BOARD OF SUPERVISORS
AGENDA LETTER

SUBJECT: **ExxonMobil/Sunset Appeal** (Case No. 08APL-00000-00019) of County Planning Commission Approval of PXP Tranquillon Ridge Oil and Gas Development Project (Case No. 06RVP-00000-00001); Third and Fourth Supervisorial Districts.

**RE: Case Number 06RVP-00000-00001
Appeal of Planning Commission April 21, 2008 Decision on the PXP
Tranquillon Ridge Project**

Figure 3-3
VAFB Onshore Alternative Pipeline Scenario 1

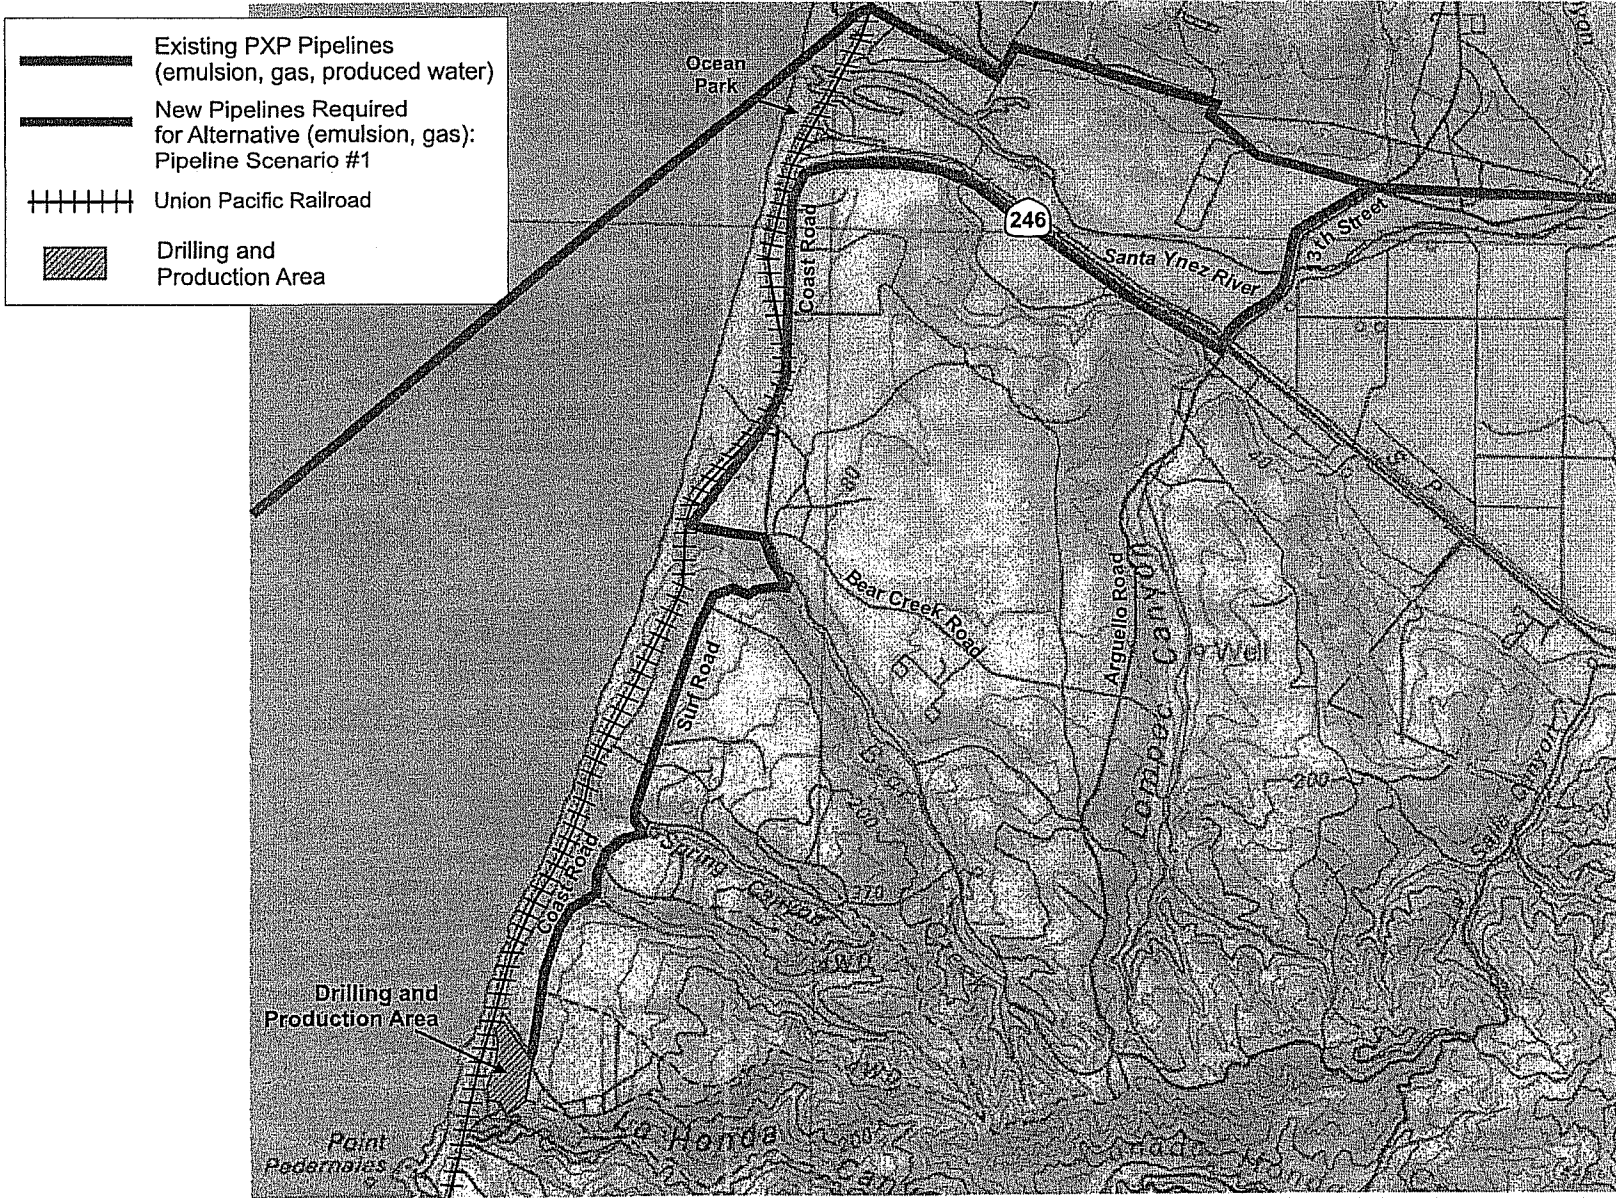
7	ES.3	Description of Project Alternatives	Section indicates in 'VAFB Onshore Alternative' (Figure 3-3) the proposed routing for the new pipeline (Pipeline Scenario 1).			X	Request that the DEIR be revised to reanalyze the pipeline route described in the VAFB Onshore Alternative (Pipeline Scenario 1) since it is not optimized in several areas including the the approach for crossing Bear Creek and proximity to the Santa Ynez River estuary. The Vahevala project utilizes an environmentally favorable pipeline route (based upon extensive field evaluations and discussions with VAFB personnel) which includes a horizontal directional drill (HDD) under Bear Creek and Bear Creek Road and a route with further setback away from the Santa Ynez River estuary. This route also is optimized with respect to minimizing impact on cultural resources, again based on consultation with VAFB personnel. Additionally, as per Figures 3-4, 3-5, 3-6, 3-7 and 3-8, the VAFB Onshore Alternative Pipeline Scenarios 2 through 6 are all suboptimal with respect to environmental, cultural and VAFB infrastructure impacts as compared to the Vahevala proposal. Reference comments provided in the specific issue areas of the DEIR.
